COMANCHE PEAK STEAM ELECTRIC STATION  
OMISSION OF SHEAR TIE REINFORCING STEEL  
APPROXIMATE ELEVATION 993 to 997  
UNIT No. 2 - REACTOR CONTAINMENT BUILDING  
CONCRETE PLACEMENT NO. 201-5805-032

GTN- 39821

TEXAS UTILITIES GENERATING COMPANY  
COMANCHE PEAK STEAM ELECTRIC STATION  
1931-83 - 2300 MW INSTALLATION  
G&H PROJECT NO. 2323  
ENGINEERING EVALUATION OF AS-BUILT  
UNIT 2 CONTAINMENT  
ELEVATIONS 993'-1 1/2" AND 996'-9 1/2"  
REF 1: TWX-11,384, DATED 8/28/79  
REF 2: DCA 5536, REV. 1, DATED 9/10/79  
REF 3: GTT-4188, DATED 9/6/79

COMANCHE PEAK STEAM ELECTRIC STATION  
DESIGN CHANGE AUTHORIZATION

PART ELEVATION OF WALL  
SHOWING AS-BUILT  
SHEAR REINFORCEMENT

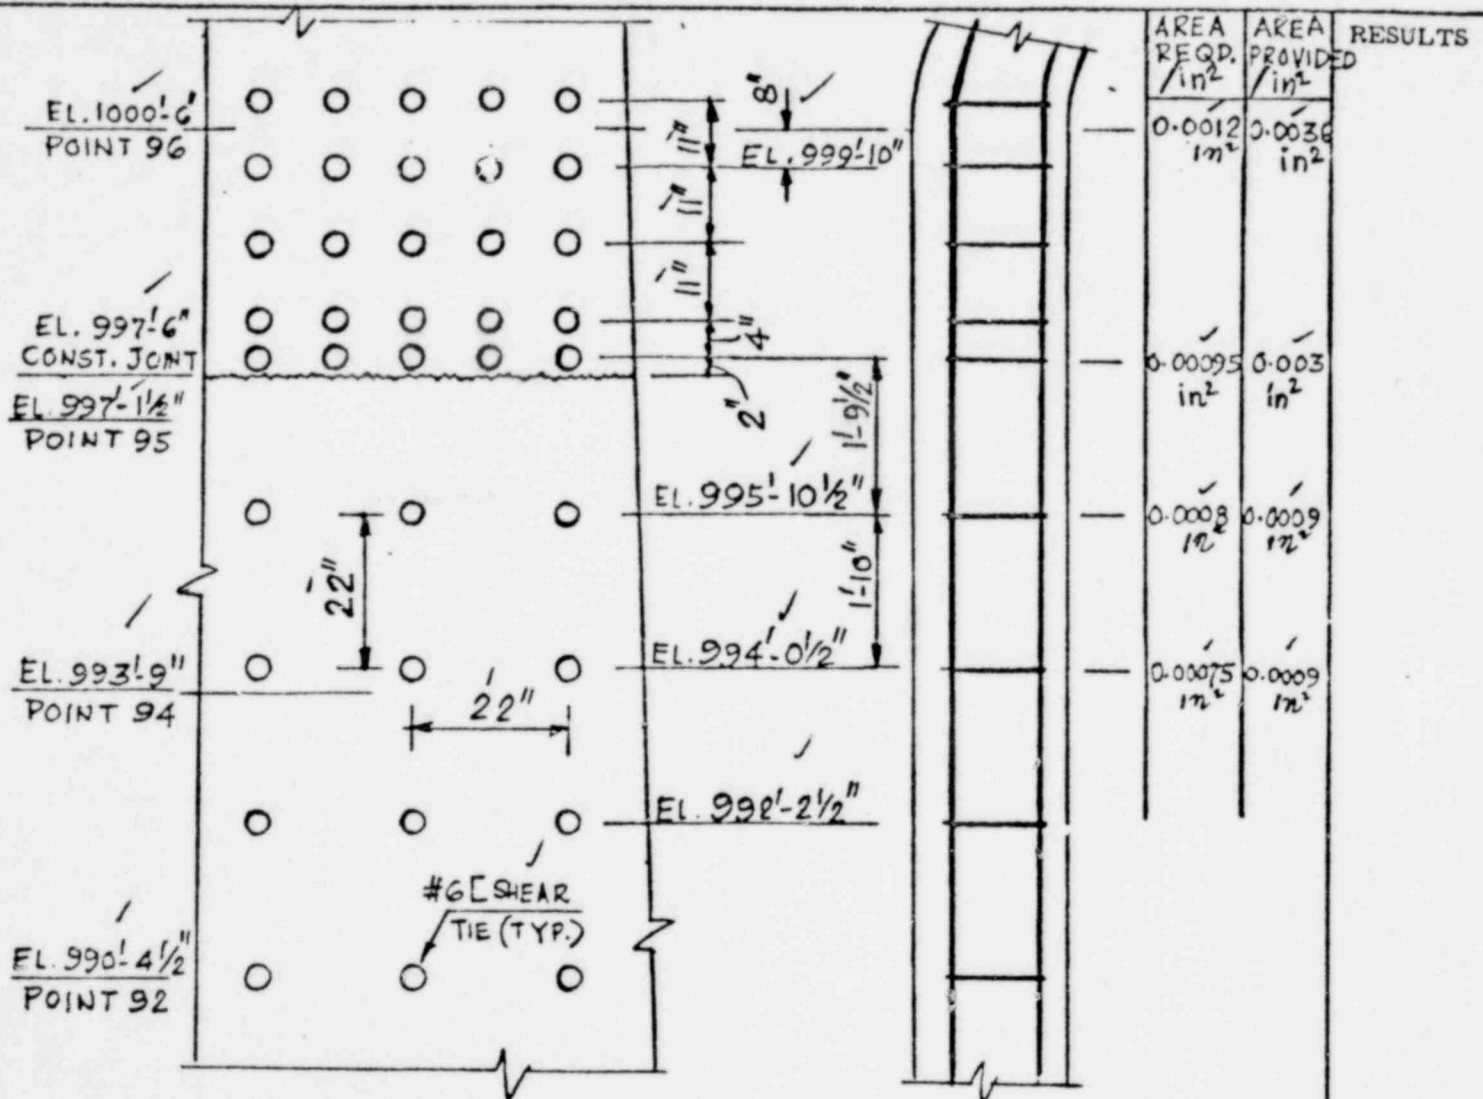
3 Rows of Addl. # 6 shear bars as shown in  
drg. # 2323-S2-0505 REV. 5 bet. EL. 993'-1 1/2" and  
996'-9 1/2" were omitted in the field.

The object is to determine if this  
as-built condition without additional shear ties  
between EL. 993'-1 1/2" and 996'-9 1/2" is acceptable.

ALTERNATE CALCULATION (SEE SKETCH ON PAGE 3/2):

$$A_v \text{ Req'd.} = \frac{69.31 \times 1 \times 1}{60000} = 0.0012 \text{ in}^2 / \text{inch in both direc.}$$

$$A_v \text{ provided} = \frac{0.44}{11 \times 11} = 0.0036$$

O.K.

(B) POINT 95 (EL. 997'-1 1/2"):

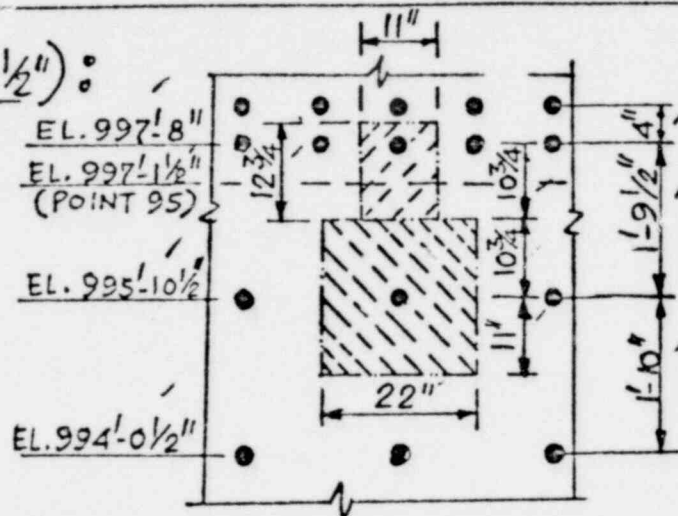
Total Radial shear at EL. 997'-8" (obtained by interpolation  
 bet. points 95 & 96)

$$Q = 2.15 + \frac{(2.71 - 2.15) \times 6.5}{40.5} = 2.24 \text{ K/in}$$

Total Radial Shear at EL. 995'-10 1/2" (obtained by interpolation  
 between points 95 & 94)

$$Q = 1.58 + \frac{(2.15 - 1.58) \times 25.5}{40.5} = 1.95 \text{ K/in}$$

Refer sketch on Page 3/11,  $S = 11''$  and  $h = 12\frac{3}{4}''$

$$\therefore A_{v \text{ Req'd.}} = \frac{57.29 \times 11 \times 12.75}{60000} = 0.134 \text{ in}^2$$

Area provided = 1- #6 bar ( $0.44 \text{ in}^2$ ) O.K.

FIG. 2

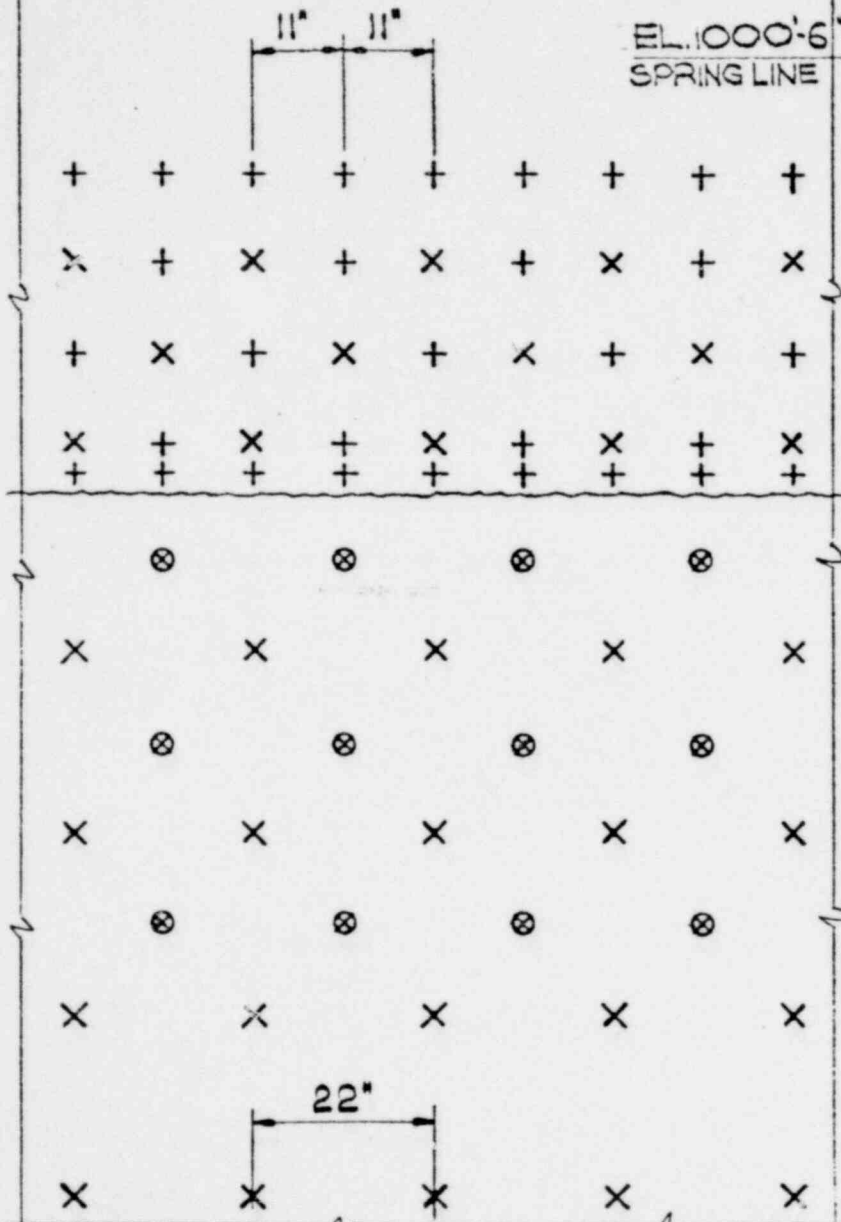
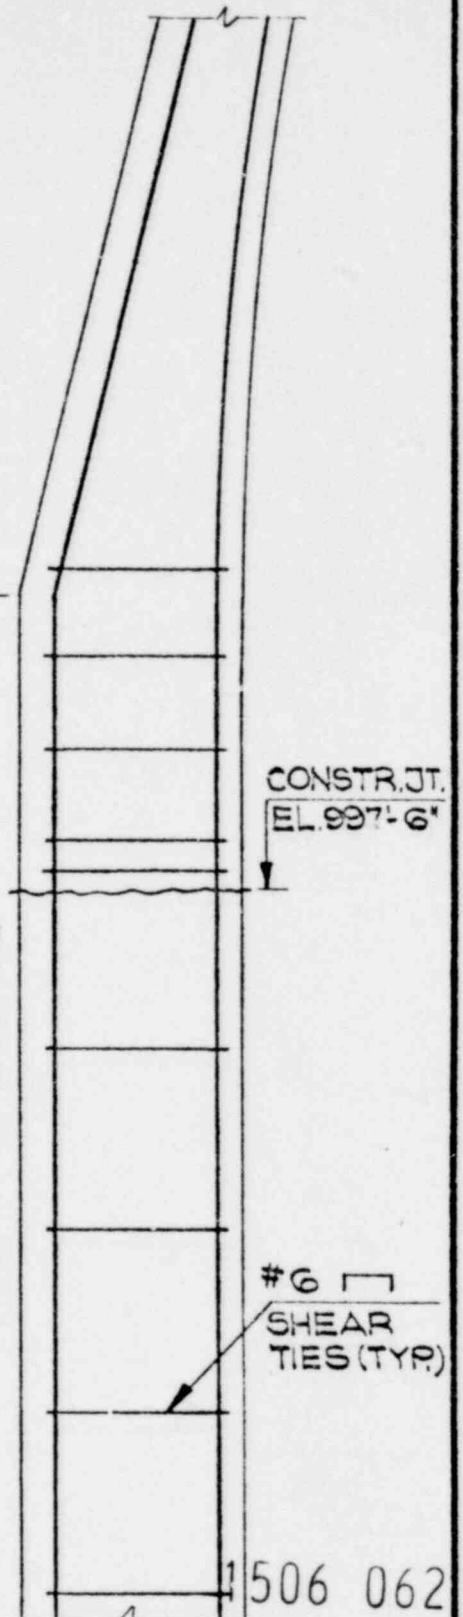
- X-DENOTES SHEAR TIES SHOWN ON CONSTRUCTION DWG. # 2323-S2-0503
- + DENOTES ADDITIONAL SHEAR TIES OVER AND ABOVE THAT SHOWN ON CONSTR. DWG. # 2323-S2-0503
- ⊗-DENOTES SHEAR TIES SHOWN ON CONSTRUCTION DRAWING # 2323-S2-0503 WHICH WERE OMITTED.

Therefore, the shear forces determined using Model No. 3 were used to verify the as-built shear reinforcement and the as-built condition was found to be more than adequate. It should be noted that with Model No. 3 computed loads all the shear load in the subject area is assumed to be resisted by the shear tie reinforcing only and no reliance is placed on the shear capacity of the concrete. If, in fact, Model No. 1 or Model No. 2 were applied, then there would be shear capability in the concrete which was ignored in Model No. 3. In this event, the concrete would resist some of the shear load. The total shear load would be resisted by the concrete together with the as-built reinforcing steel shear ties. Accordingly, the Engineer concludes that the as-constructed condition is acceptable. The remedial action as described in DCA-5536, Rev. 1 is adequate to assure the integrity of the Unit 2 containment in the design bases condition.

As-built condition is acceptable without  
additional shear ties between EL. 993'-1 1/2" and  
EL. 996'-9 1/2". See detail calculations on  
pages 3/2 to 3/16 ✓

FIG. 1

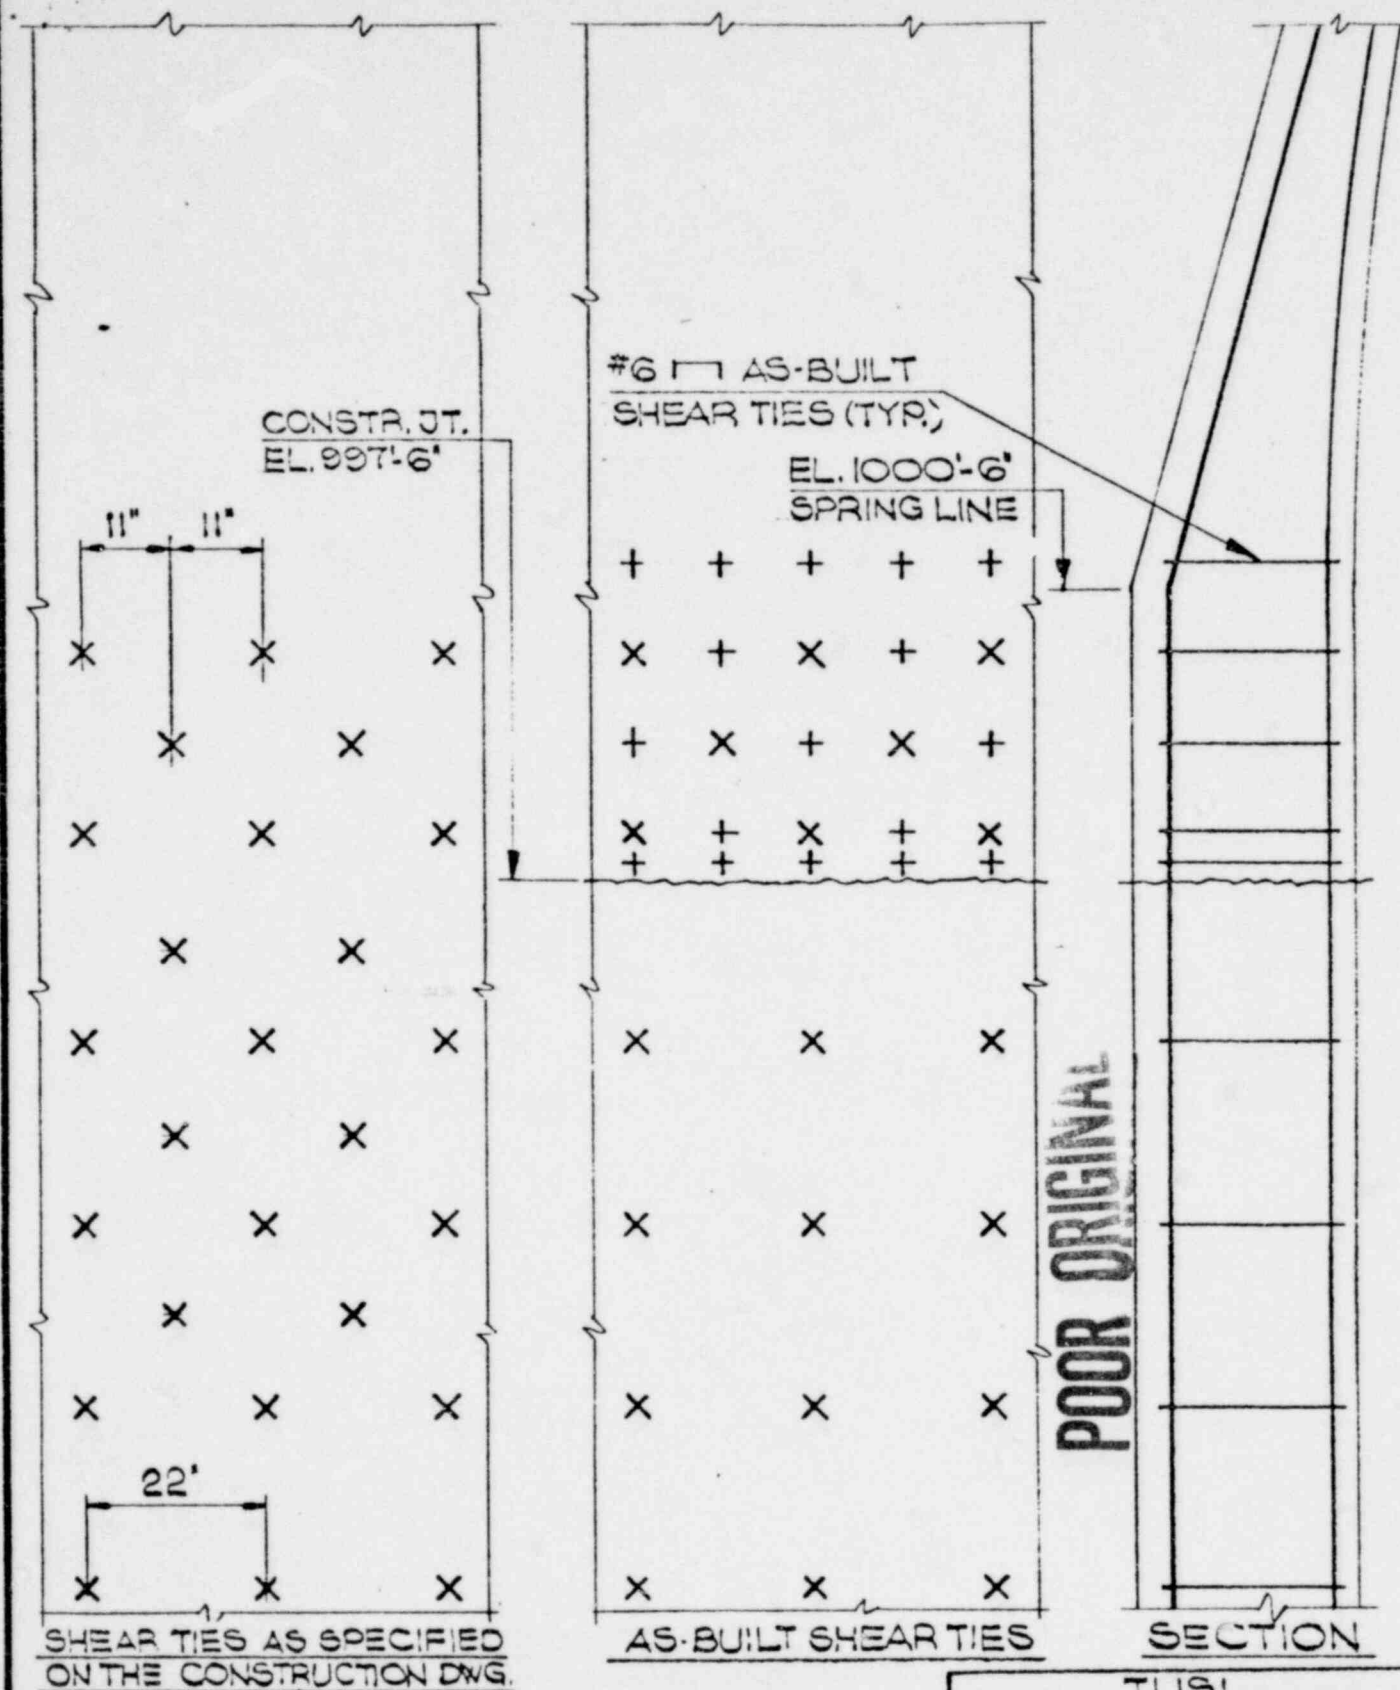
ADDITIONAL #6 SHEAR TIES AT 1'-10" VERTICAL AND 1'-10" APPROXIMATE HORIZONTAL ALTERNATE WITH MAIN SHEAR BARS BEGINNING AT EL. 993'-12 1/2" AND ENDING AT EL. 996'-9 1/2" HAVE NOT BEEN PLACED. MAIN SHEAR REINFORCEMENT HAS BEEN PLACED IN ACCORDANCE WITH THE DESIGN DRAWING. CONCRETE HAS BEEN PLACED IN ACCORDANCE WITH THE DESIGN DRAWING. CONCRETE AS BEEN PLACED TO APPROXIMATE EL. 997'-6".

REQUEST ENGINEERING EVALUATION OF THE THREE OMITTED ROW OF SHEAR TIES AT EL. 993'-12 1/2", 994'-11 1/2" AND 996'-9 1/2" FOR ACCEPTANCE TO USE-AS-IS.
